Chapter 14 – Human Health

AAP01-000-GEG-GGEN-00002

Project: **Australia-Asia PowerLink**

Figure 14-1: Area of influence from construction air emissions Adelaide Creek OHTL

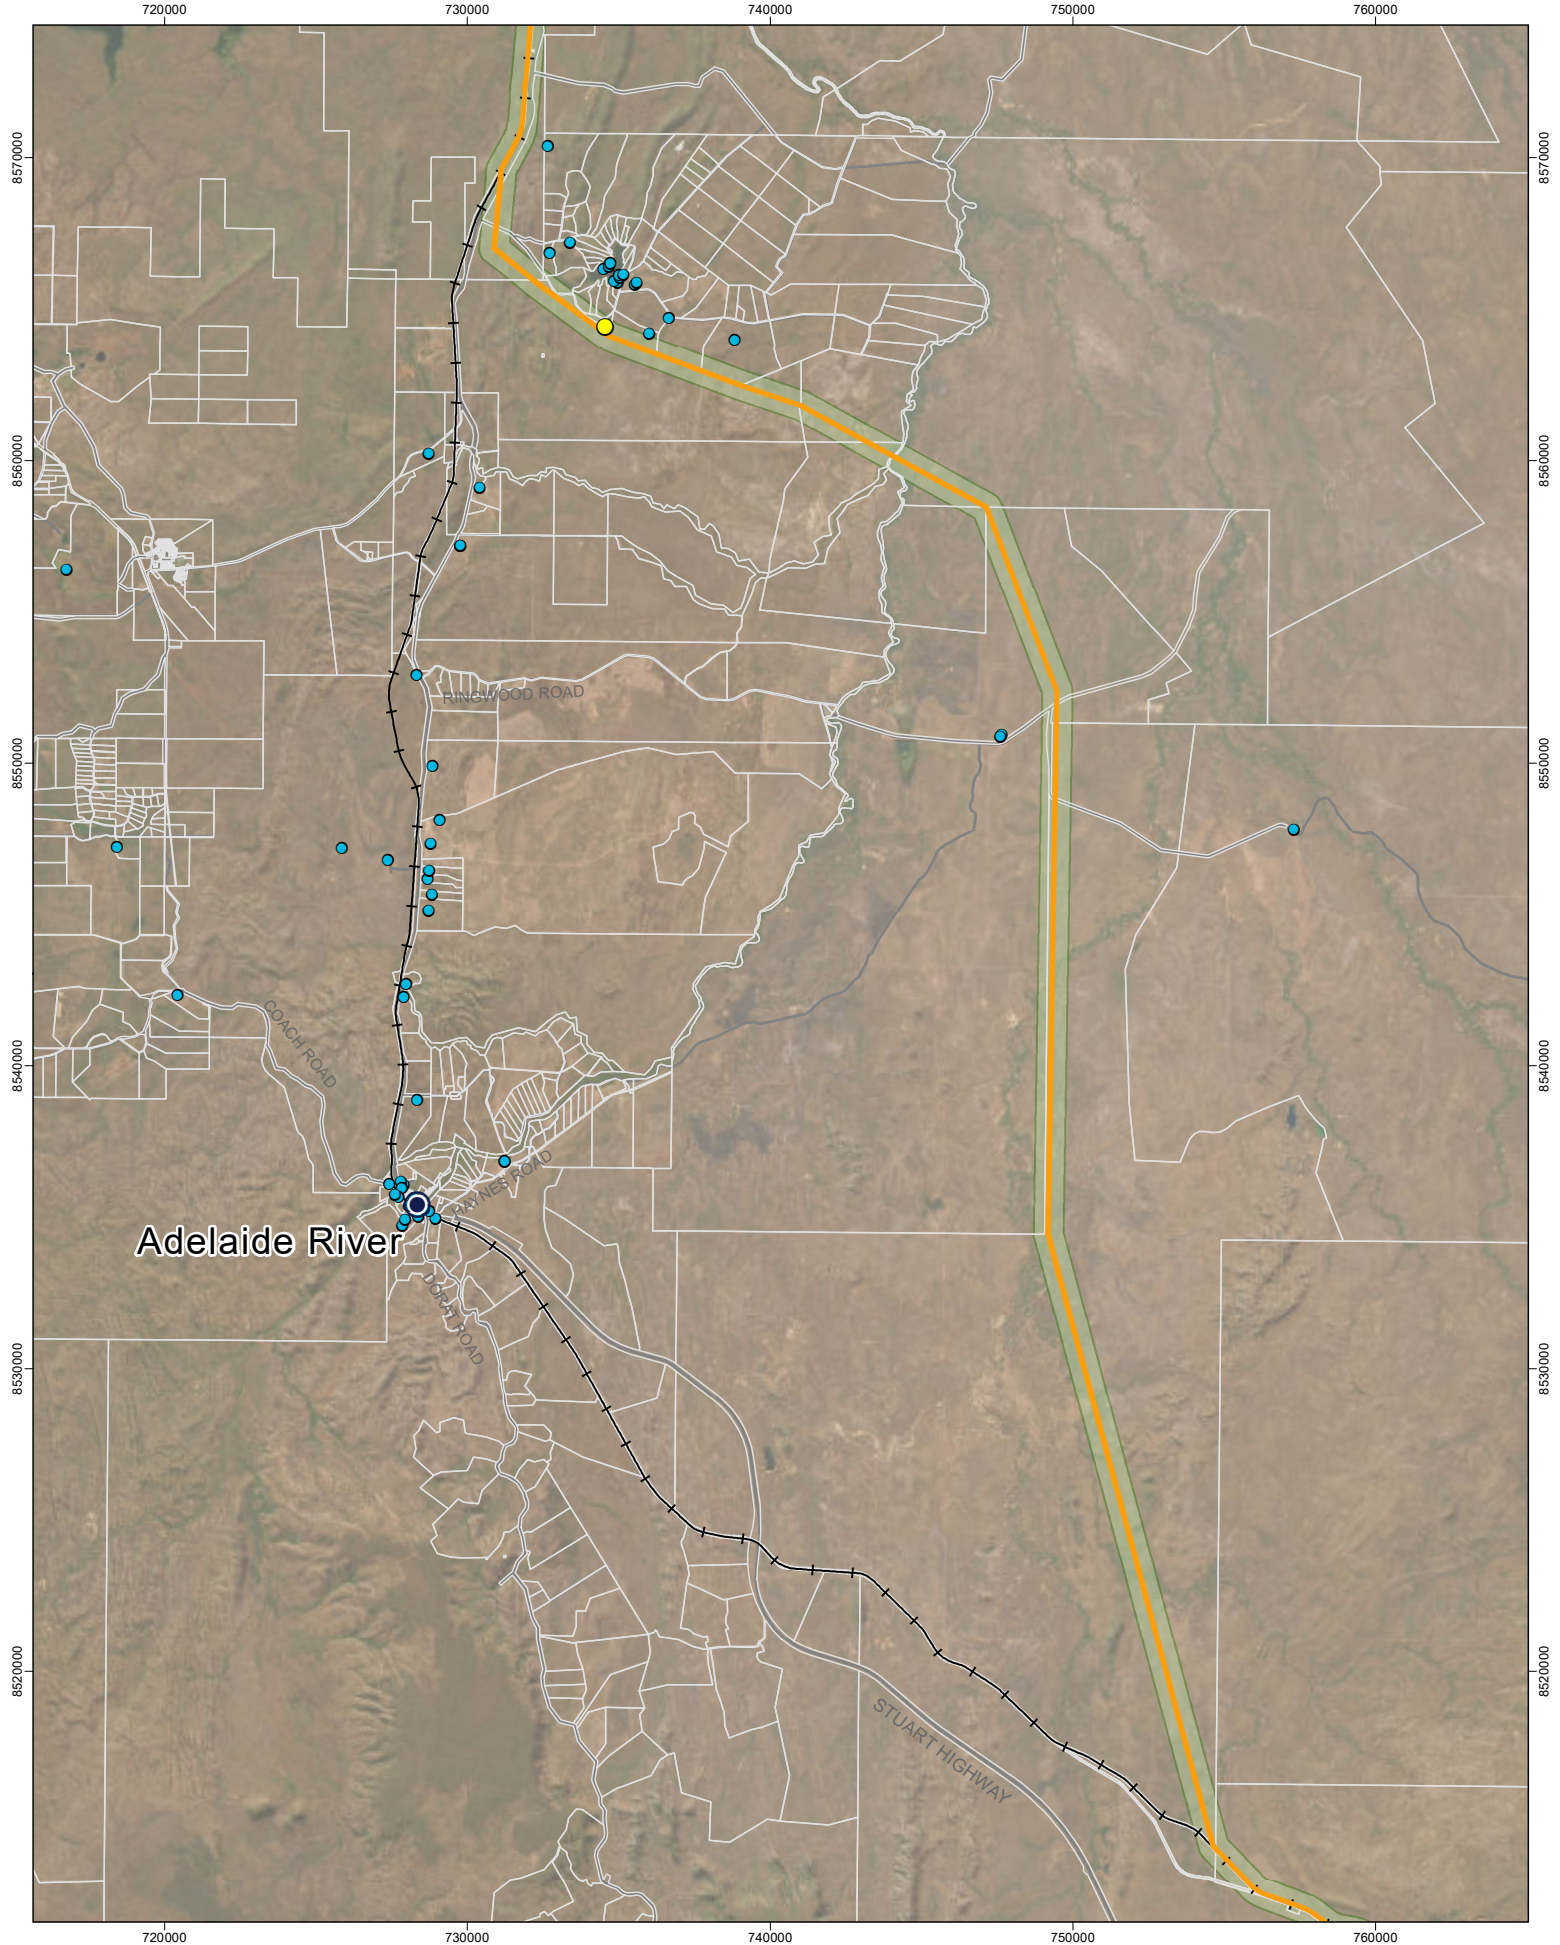
The draft EIS notes that some of the sensitive receptors presented in Chapter 11 will be avoided by the alternative routes near Katherine, Pine Creek and Adelaide River. However, any new sensitive receptors likely to be impacted and proposed avoidance and mitigation measures in the alternative routes are not presented in the proponent's draft EIS.

Provide information and additional assessment of impacts from dust emissions, if necessary, about the proposed alternative location of the OHTL corridor, as required by the previous item above.

Changes in the distance to sensitive receptors resulting from the OHTL Corridor is included in Section 14.3. Section 14.4.3 assesses the change to the dust risk resulting from the selected deviation. The Constraints Planning Framework and Field Development Procedure (Appendix 4.1) has been designed to highlight high risk areas for dust and implement additional controls as required under a TARP.
